**Demolition of Infrastructure and Vegetation Removal at Midewin National Tallgrass Prairie  
Statement of Work and Request for Proposals  
RFP Revision: February 17, 2020**

Questions from the Pre-Bid Call on February 5, 2020  
Demolition of Infrastructure at Midewin National Tallgrass Prairie

(a) Project Location- Midwin National Tallgrass Prairie

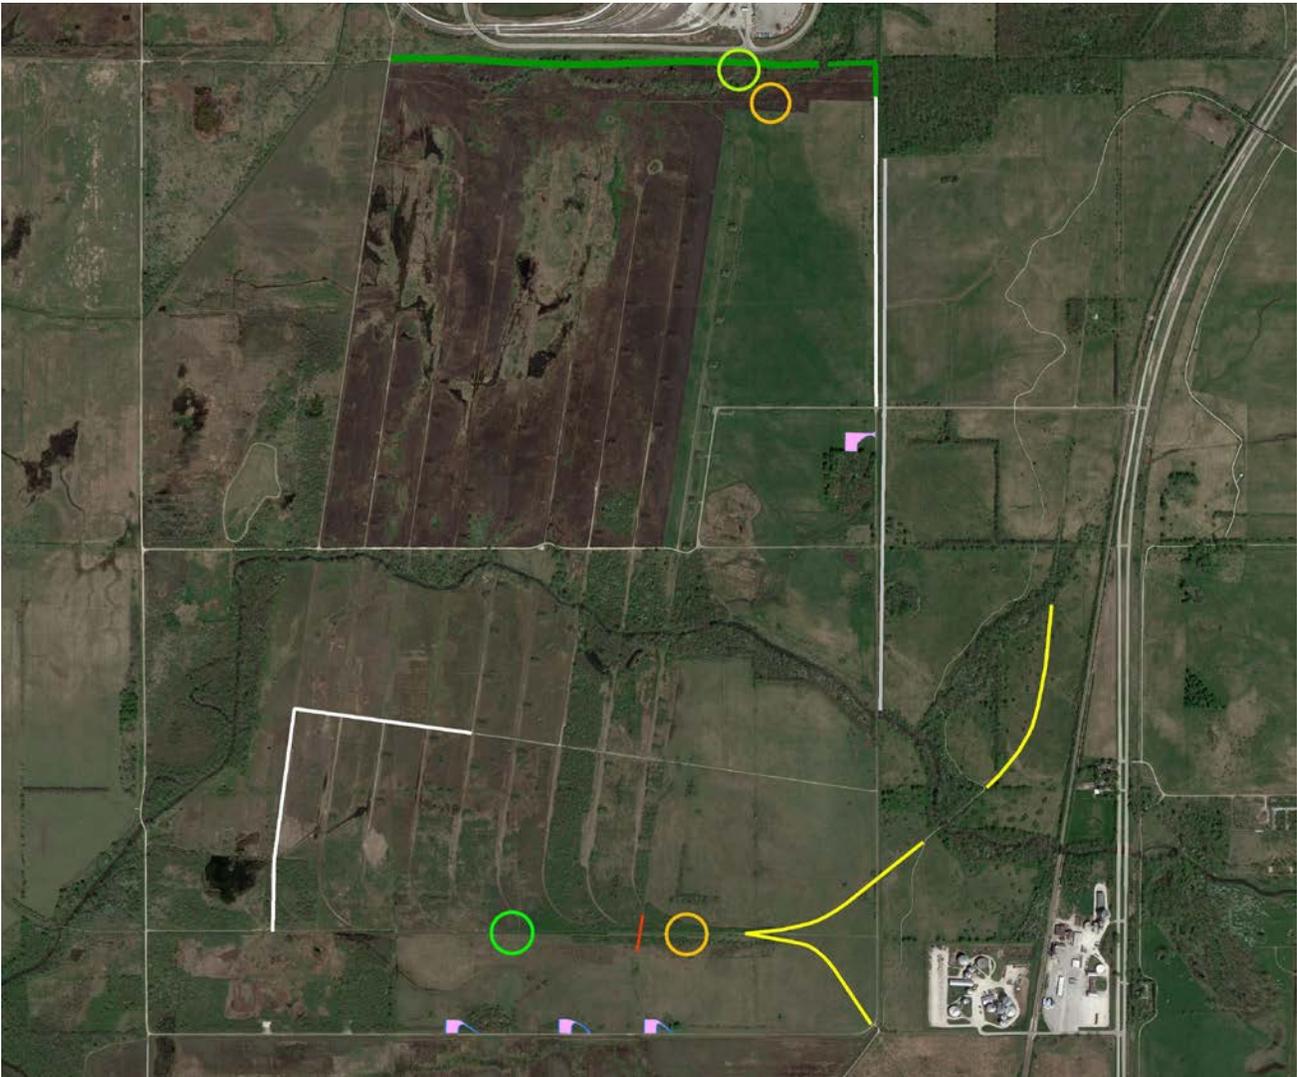
3. Question: What is the haul distance from the three South Patrol Road parking pads to the four spoils dumping areas?
  - Answer: By road, the distance is 1.0 miles from the easternmost pad to the easternmost spoils dumping area (in orange; see updated map). It is 1.2 miles from the middle parking pad, and 1.45 miles from the westernmost parking pad. Taking a short cut across the cattle pasture is not currently an option.
  - A dumping area is noted on the map in orange for material coming from south of Grant Creek, and a separate dumping area is shown in light green for material originating from north of Grant Creek.

The above photo shows the location of the roads, rail lines, fence lines, and parking pads to be removed. These are the same locations where trees and shrubs need to be removed in order for the infrastructure to be accessed and removed. Also shown are the areas where spoils are to be deposited (designated in circles). The only Grant Creek crossing is at the west end of the dark green road (Townline Rd.). The surfaced roads are paved with asphalt (in dark green), and the unsurfaced roads are covered in gravel (in white). The rail lines are in yellow. The north light green circle is north of Grant Creek, while the north orange circle is south of Grant Creek. The south light green circle is west of a gate on the access road (gate in red) and accessible from the west, while the south orange circle is east of that gate and accessible from the east. The parking pads are in pink, and the fence is in gray.
